Access Compliance Report

Public Rights-of-Way

(Curb Ramps)

Intersection ID: 12830	Main Street: CARYA_POND_LN	Cross Street: HICKORY_GROVE_RD	Location:	N
ADA ID: F1C7A84A1355	Ramp Type: Combination1	Initial Pass/Fail: Fail	Overall Compliance: No	Severity Score: 22.5

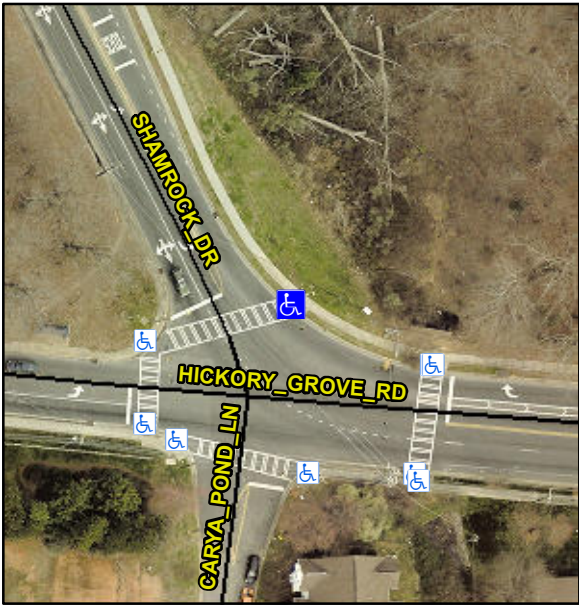
Codes/Mitigation Info/Possible Solution				Field Measurements/Component Compliance							
	Possible Solutions:			Compliance	Description	Data	Compliance	Description	Data		
	Remove & Replace Entire Ramp.			N/A	Ramp Length LT (in)	64.5	N/A	Ramp Length RT (in)	68.0		
				Yes	Ramp Width LT (in)	59.0	Yes	Ramp Width RT (in)	60.0		
				Yes	Ramp Slope LT (%)	7.3	Yes	Ramp Slope RT (%)	1.8		
				No	Ramp XSlope LT (%)	3.9	No	Ramp XSlope RT (%)	4.0		
				N/A	Ramp Length (in)	48.0	No	Ramp Slope (%)	9.1		
				No	Ramp Width (in)	45.5	No	Ramp XSlope (%)	3.4		
	Surveyor Notes:			N/A	Flare Type LT	N/A	N/A	Flare Type RT	N/A		
	RT RP < 5%			N/A	Flare Slope LT (%)	N/A	N/A	Flare Slope RT (%)	N/A		
				N/A	Flare Traversable LT?	N/A	N/A	Flare Traversable RT?	N/A		
PROW/ADA:			N/A	Landing Length (in)	N/A	N/A	DWS Provided?	N/A			
Not Found, R304.5.1, R304.2.2, R304.5.3			N/A	Landing Width (in)	N/A	N/A	DWS Contrast?	N/A			
			N/A	Landing Slope (%)	N/A	N/A	DWS Length (in)	N/A

N/A	Landing X Slope (%)	N/A	N/A	DWS Full Width?	N/A			
			N/A	Landing Curb? (Y/N)	N/A	N/A	DWS Offset (in)	N/A			
			N/A	Shared Landing?	N/A						
			N/A	Gutter Ponding?	N/A	N/A	Gutter Slope (%)	N/A			
			N/A	Gutter Lip Ht (in)	N/A	N/A	Gutter X Slope (%)	N/A			
			N/A	Painted X Walk1?	Yes	N/A	Painted X Walk2?	N/A			
				X Walk 1 Direction	To SW		X Walk 2 Direction	N/A			
				X Walk 1 Width (in)	122.0		X Walk 2 Width (in)	N/A			
				X Walk 1 Slope (%)	3.9		X Walk 2 Slope (%)	N/A			
				X Walk 1 X Slope (%)	1.9		X Walk 2 X Slope (%)	N/A			
			N/A	Ramp inside XWalk1?	Yes	N/A	Ramp inside XWalk2?	N/A			
				Road Slope (%)	N/A		Clear Space?	N/A			
				Road X Slope (%)	N/A	N/A	Clear Space to XWalk (in)	N/A			
						N/A	Any Obstruction?	N/A			
							Obstruction Type	N/A			
						N/A	Storm Grate/Utility Hazard?	N/A			
							Storm Grate/Utility Type	N/A			
						Yes	Surface Condition? (G/P)	Good			
							Curb Slope (%)	8.4
